**STAFF REPORT  
KETCHUM PLANNING AND ZONING COMMISSION  
MEETING OF SEPTEMBER 15, 2020**

**PROJECT:** Delong Townhome Design Review

**FILE NUMBER:** P20-051

**APPLICATION TYPE:** Design Review

1 SITE & LANDSCAPE PLAN  
SCALE: 1/4" = 1'-0"

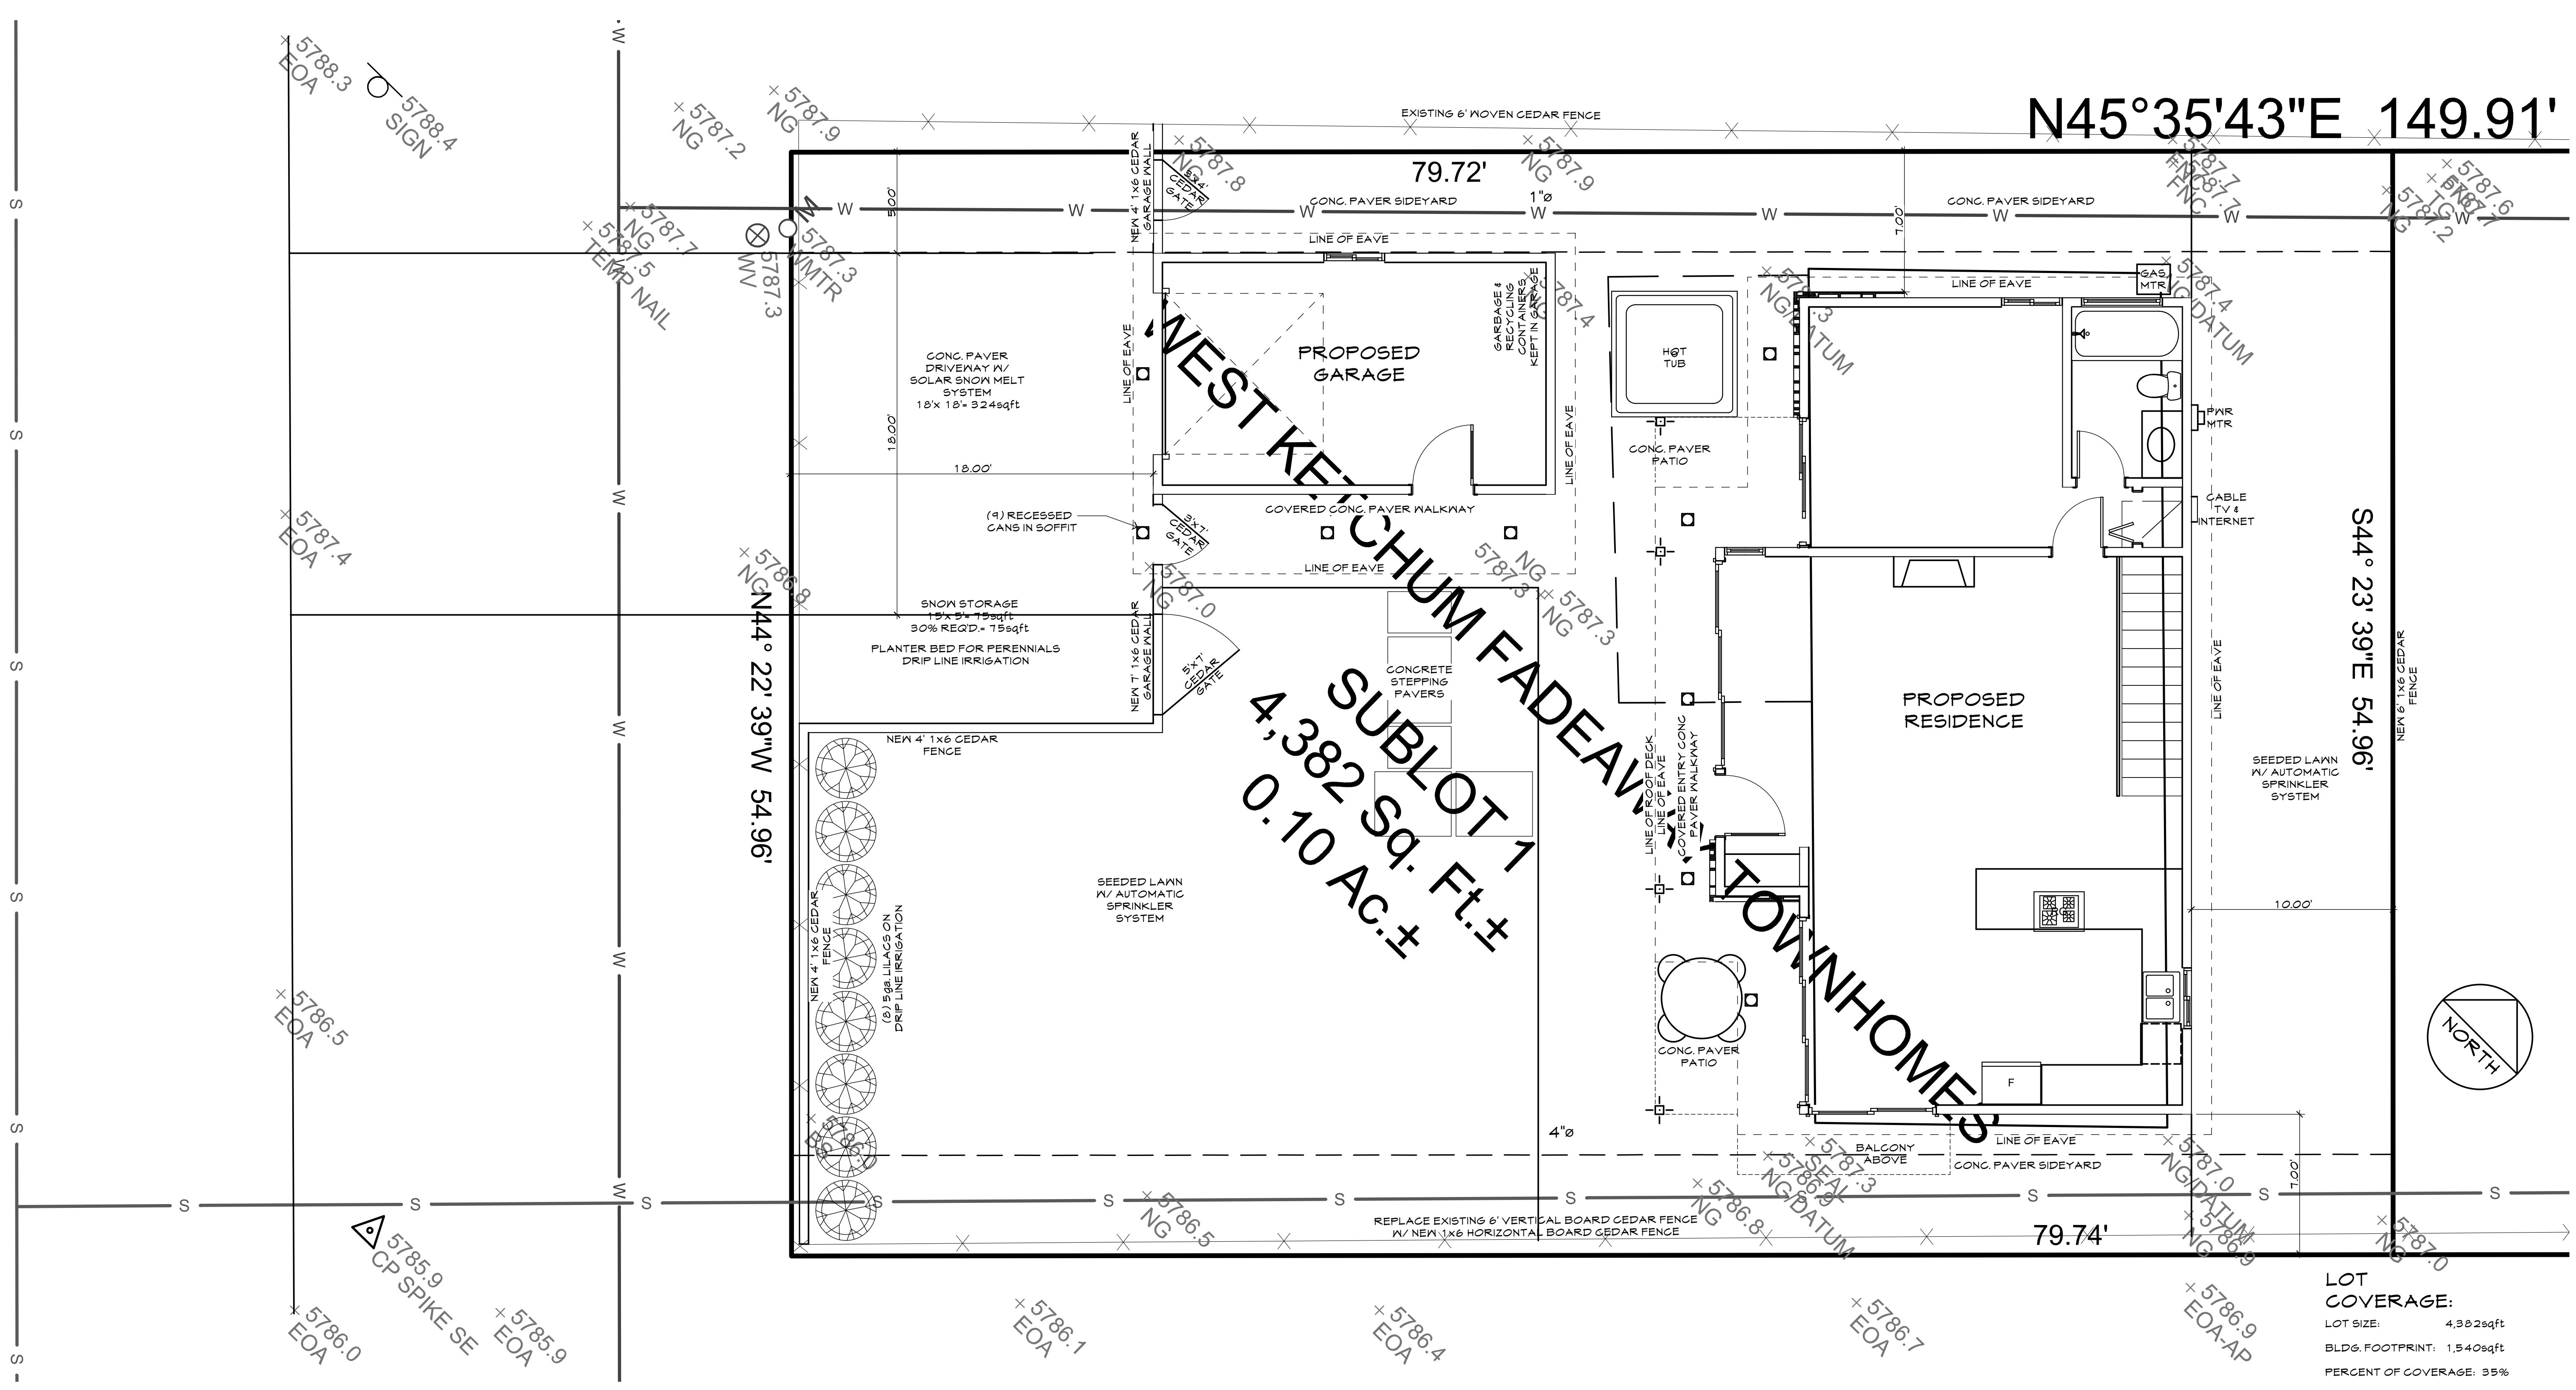
|   |   |   | <i>Staff Comments</i>              | <p><i>This project is a townhome development in a residential neighborhood accessed off 4<sup>th</sup> Avenue. As noted on Sheet 1 of the project plans, the garbage and recycling containers will be stored within the detached garage.</i></p> <p><i>The project plans do not indicate the installation of any satellite receivers. Any future installations of satellite receivers must be screened from public view.</i></p>        |
|   |   |   | <i>Staff Comments</i>              | <p><i>The site plan (Sheet 1) indicates the project's proposed circulation system, which includes paver walkways and concrete stepping pavers. The project site is located within a residential neighborhood. The site is not contiguous to an existing pedestrian, equestrian, or bicycle access.</i></p>  |

|                                     |                          |                          | <b>Staff Comments</b>           | <i>The landscape plan is indicated on Sheet 1 of the project plans. The proposed landscaping plan includes a row of lilacs that border the front property line, perennials, and lawn areas. All landscape materials and vegetation types shall be specified on the project plans submitted with the Building Permit application. All trees, shrubs, grasses, and perennials shall be drought tolerant.</i>  |
|                                     |                          |                          | <b>Staff Comments</b>           | <i>The landscape plan is indicated on Sheet 1 of the project plans. The proposed landscaping plan includes a row of lilacs that border the front property line, perennials, and lawn areas. All landscape materials and vegetation types shall be specified on the project plans submitted with the Building Permit application. All trees, shrubs, grasses, and perennials shall be drought tolerant. The applicant is encouraged to select native species.</i>  |

|                          |                          |                                     |   | <p><i>17.96.060.13, all grasses proposed in the lawn area shall be drought tolerant. Staff recommends the applicant enhance the landscaping in the backyard. More landscaping would: (1) enhance privacy between neighboring homes, (2) soften the visual impact of the flat wall at the rear elevation, and (3) enhance the appearance of the townhome development. Staff recommends additional landscaping to soften the duplex's rectangular mass, provide relief from building walls, and screen the townhome development from the street and neighboring homes.</i></p> |

C1.0

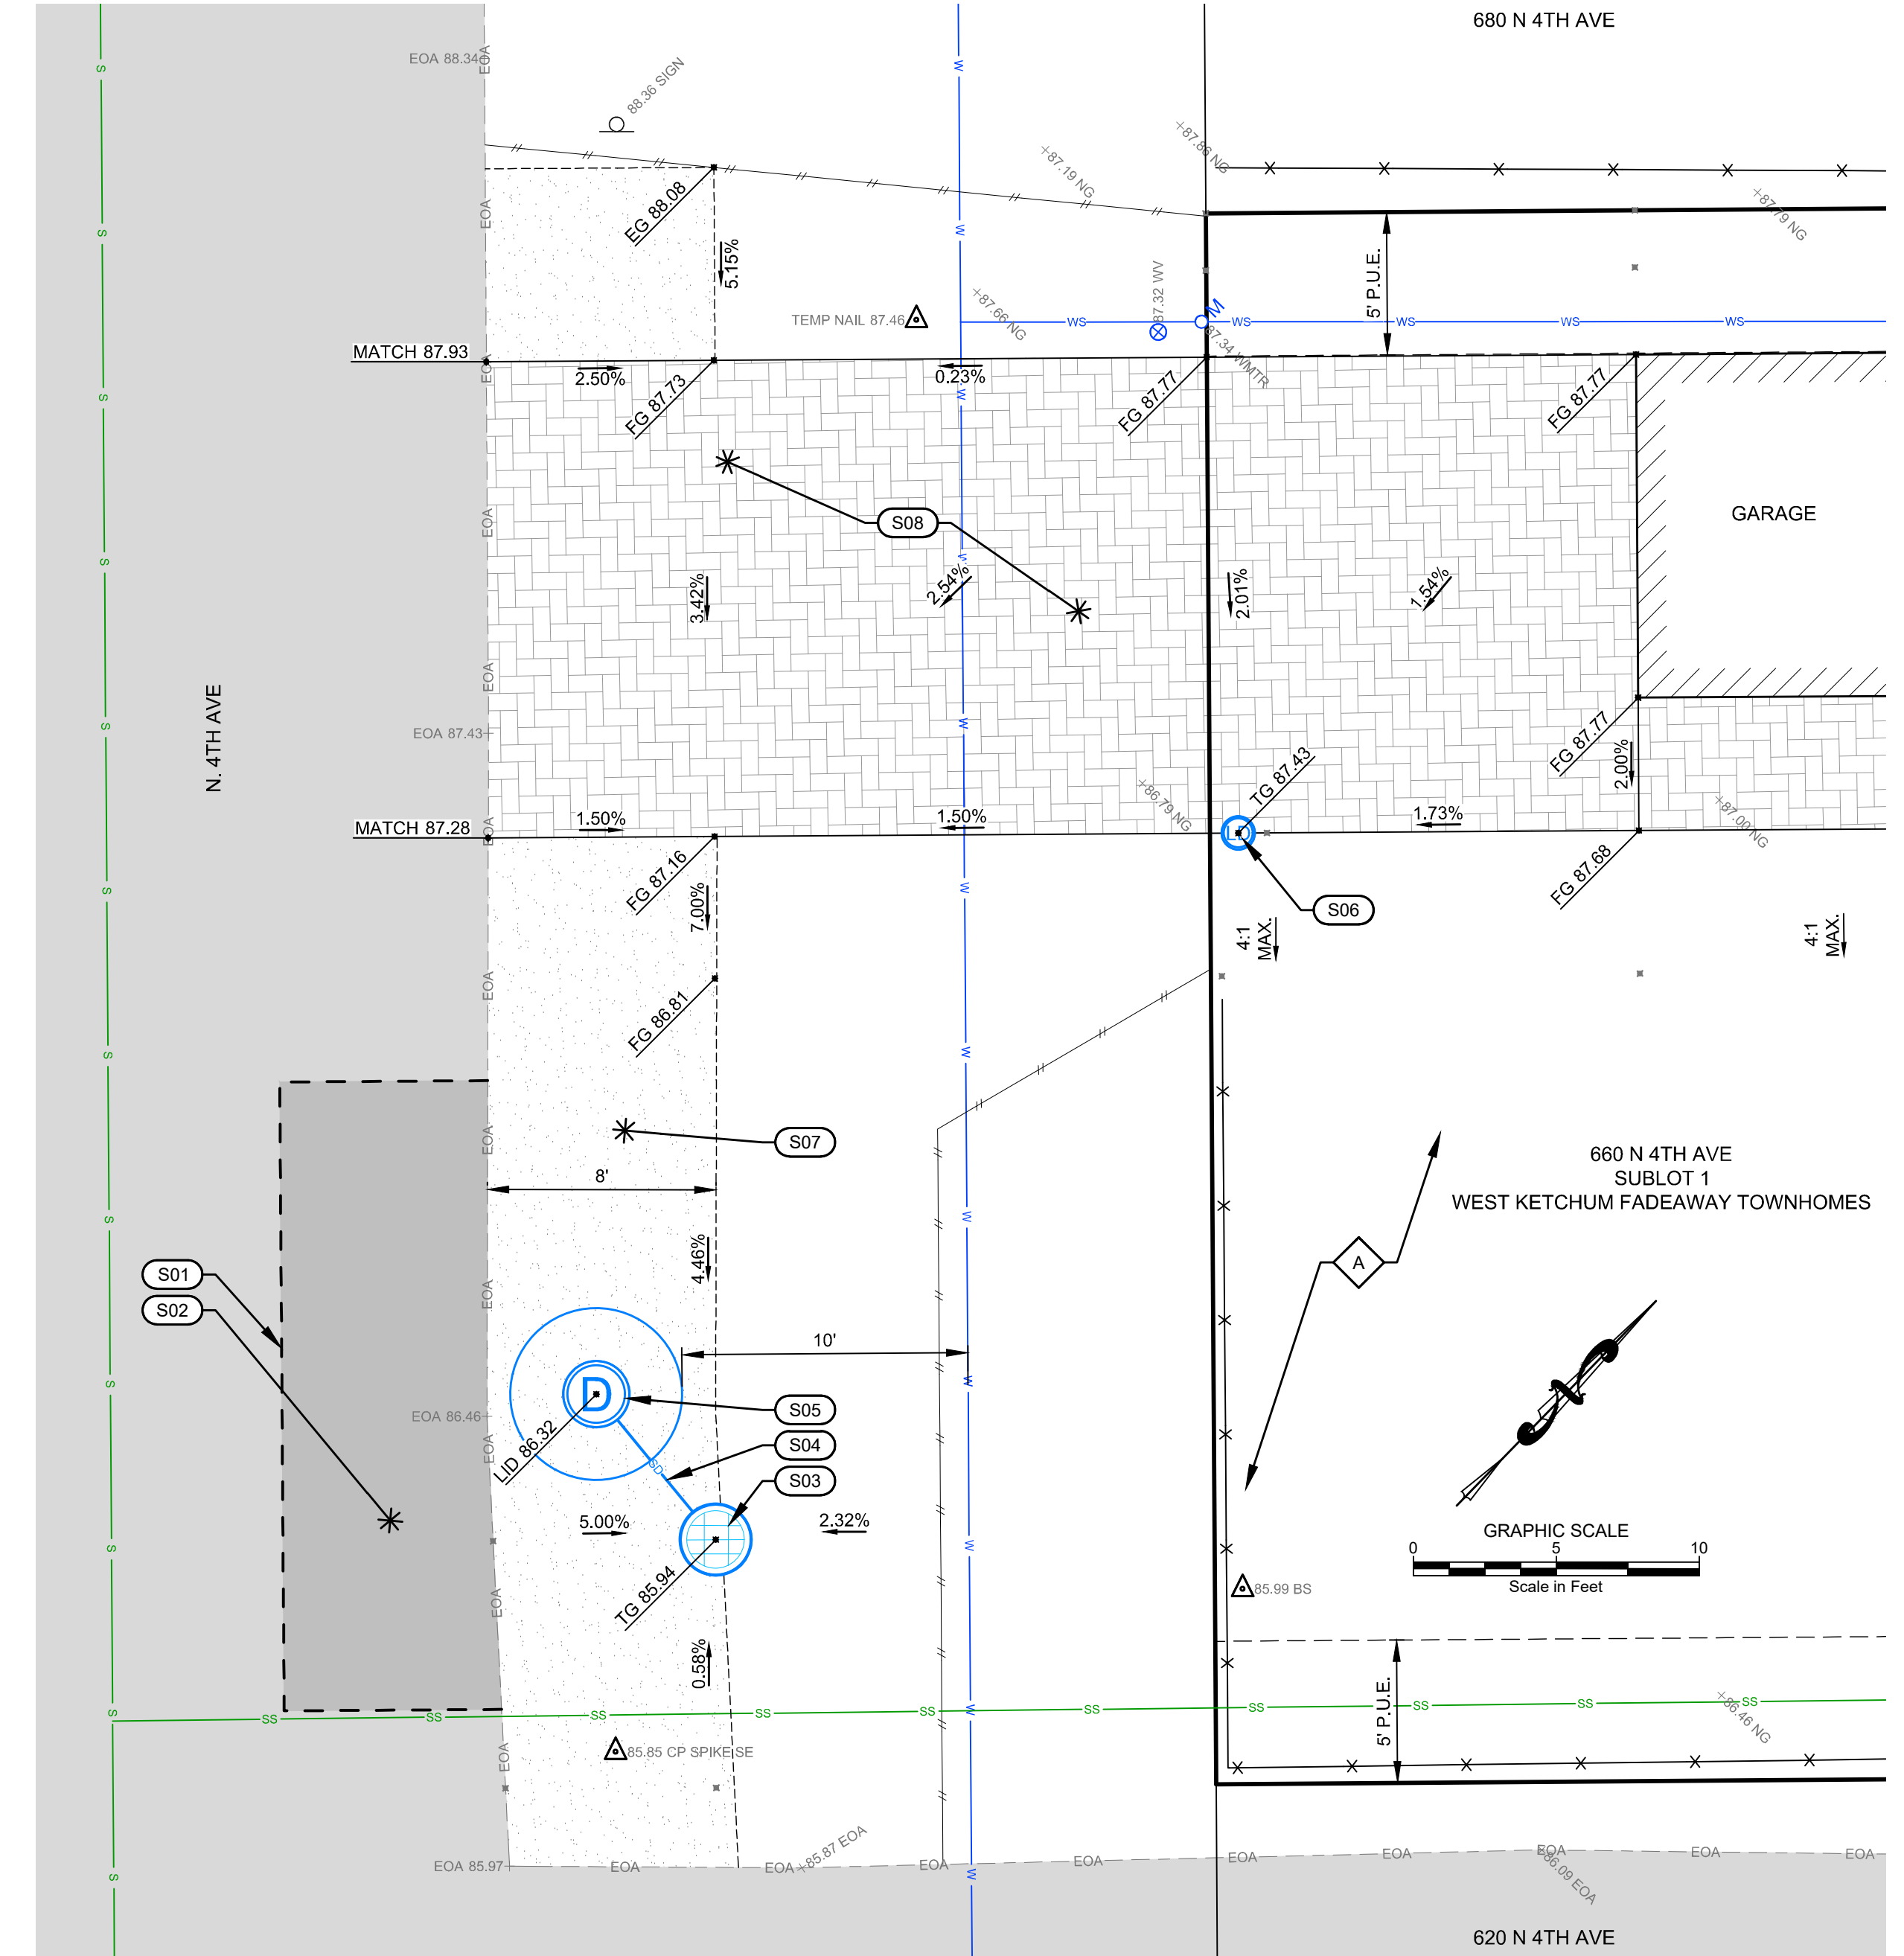
|                                     |                          |                                     | <i>Staff Comments</i>         | <i>The drainage system must keep all storm water on the project site. The developer must install drainage improvements that meet City standards. The applicant has submitted the preliminary drainage plan</i>   |

|                                     |                          |                          |                               | <p>on Sheet C1.0 of the project plans. The drainage plan proposes a system of drywells and catch basins.</p> <p>Prior to issuance of a Building Permit for the project, the applicant shall submit a final drainage plan indicating grading, catch basins, piping, and drywells (KMC §17.96.040.C.2b &amp; KMC §17.96.060.C.1-4) prepared by a civil engineer licensed in the state to be submitted for review and approval by the City Engineer and Streets Department. See Exhibit C3 for City Department comments including City Engineer and Streets Department conditions.</p>  |
| <input checked="" type="checkbox"/> | <input type="checkbox"/> | <input type="checkbox"/> | <b>17.96.060.D1 Utilities</b> | <p><b>All utilities necessary for the development shall be improved and installed at the sole expense of the applicant.</b></p> <p><i>Staff Comments</i></p> <p>All utilities necessary for the townhome project must be improved and installed at the sole expense of the applicant. The applicant has submitted the preliminary utilities plan on Sheet C1.0 of the project plans.</p>   |

|                                     |                          |                                     |   | <i>Final plans will be reviewed and approved by the Utilities Department prior to issuance of a Building Permit for the project. See Exhibit C3 for review comments and conditions from the Utilities Department.</i>   |
